Addendum 1

Notice to all holders of Bid Documents for **DACF Parking Lot Facility, 333 Cony Road, Augusta, Maine – BREM# 3035**

TYPICAL FROST WALL CROSS SECTION
RECONSTRUCTION OF PARKING FACILITY
MAINE DEPARTMENT OF AGRICULTURE
 333 CONY ROAD - AUGUSTA, MAINE
 PREPARED FOR
STATE OF MAINE

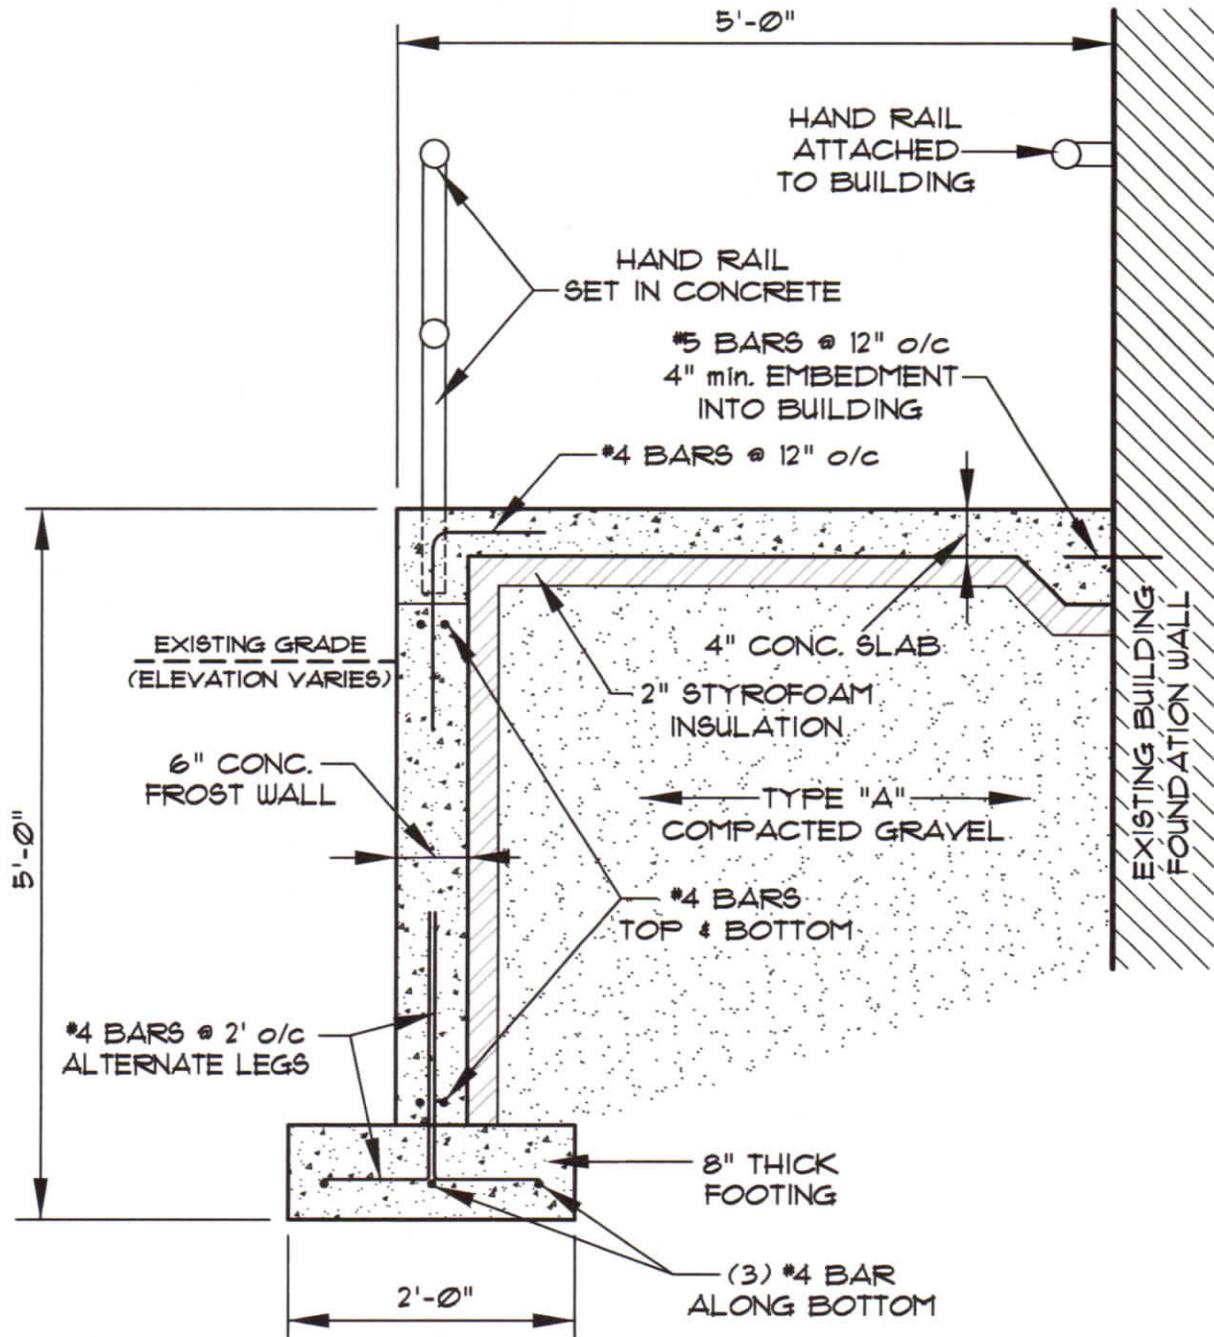
7. The entrance slab, concrete sidewalk, and landing area shall be attached to the building foundation wall with #5 rebar dowels at 12" on center. The other side of the sidewalk construction shall bear on a 5' deep 6" thick reinforced foundation wall on a 2' wide 8" thick footing. The concrete slab shall have 2" insulation under the slab and inside the wall footing. See attached sketch and detail.

HANDICAP PARKING DETAIL
RECONSTRUCTION OF PARKING FACILITY
MAINE DEPARTMENT OF AGRICULTURE
 333 CONY ROAD - AUGUSTA, MAINE
 PREPARED FOR
STATE OF MAINE

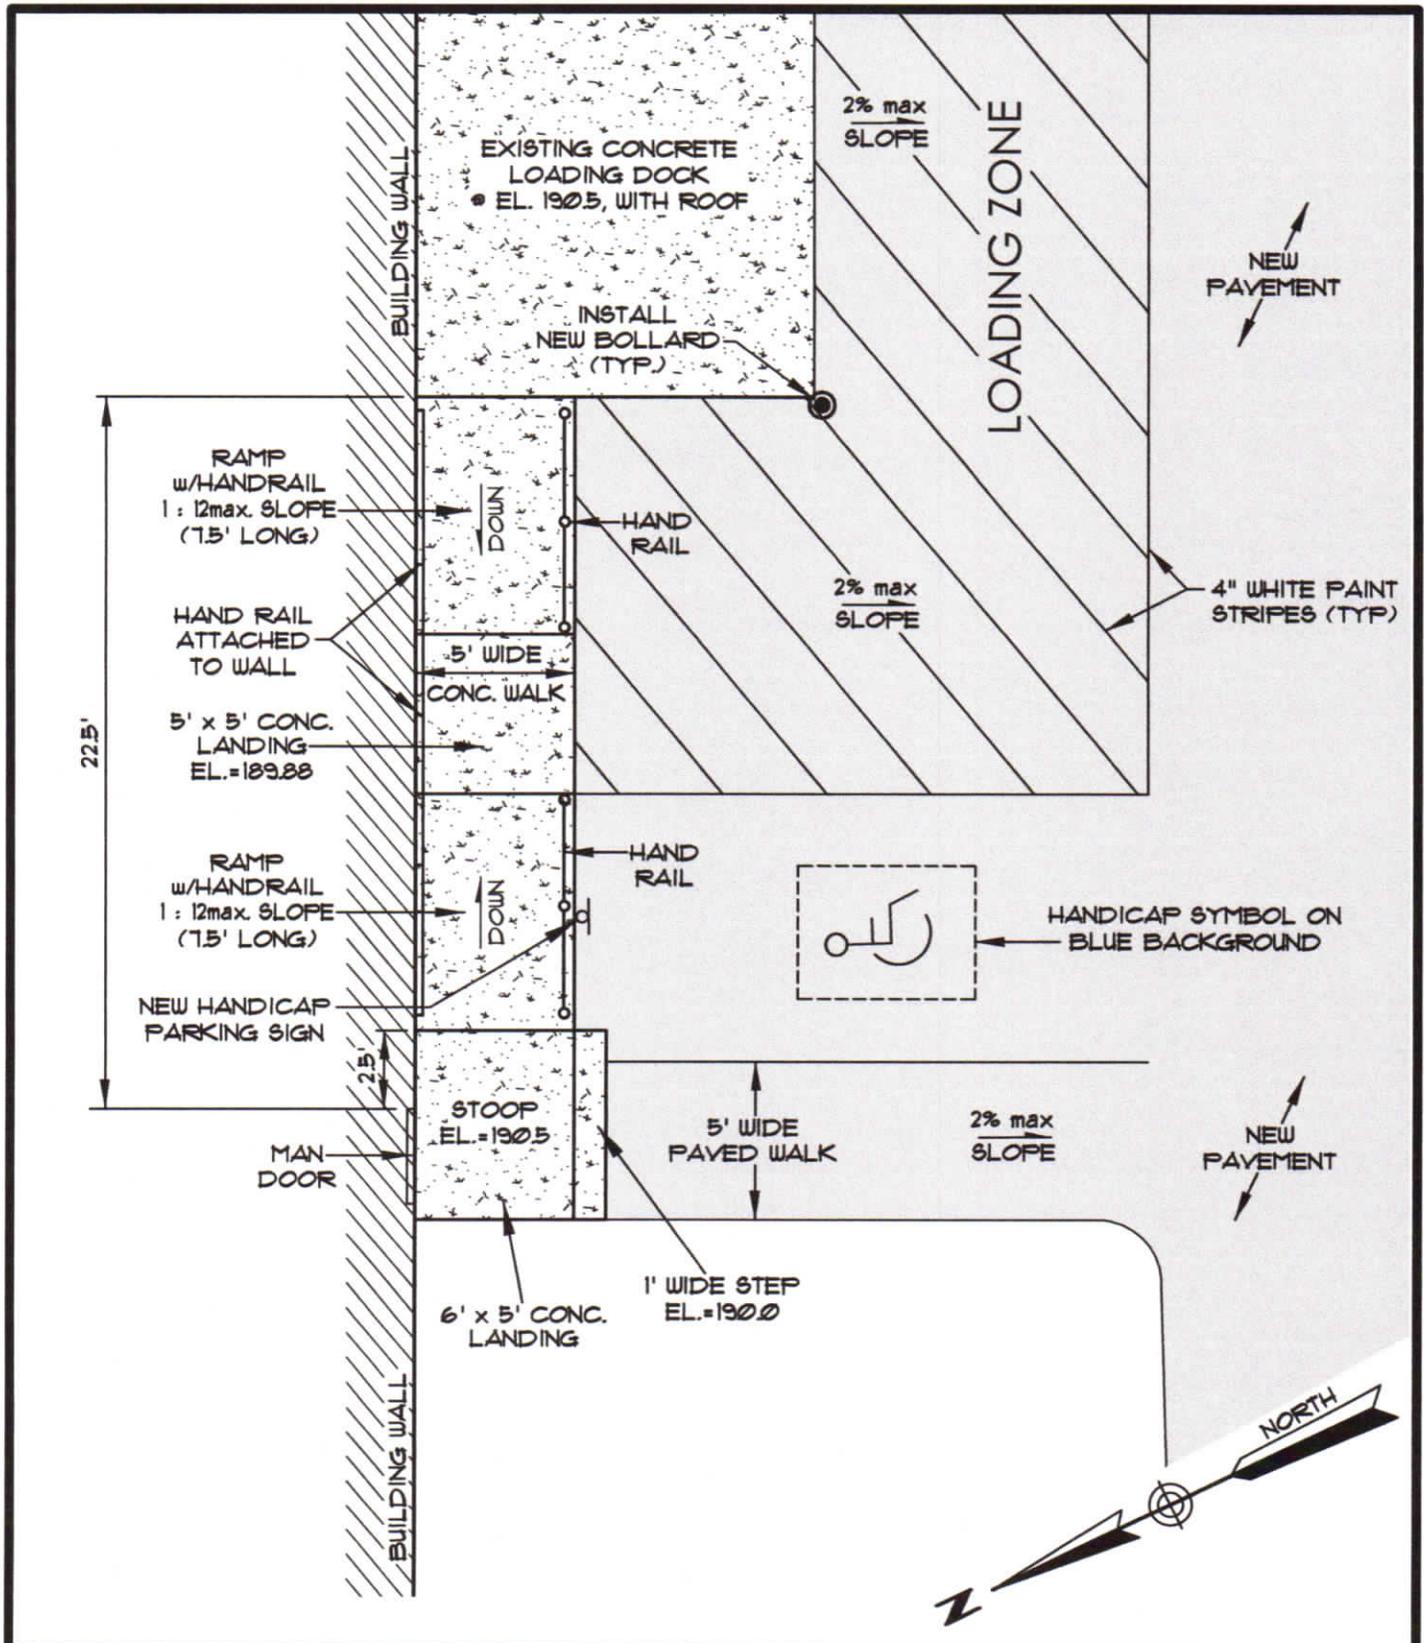
4. Parking lot stall and line work striping shall be 4" wide white paint. Handicap stall logo striping to be white paint with blue background.
5. Door stoop entry is to be 6' wide by 5' depth. The landing and sidewalk construction to be 5' wide (not 4'). See attached sketch.
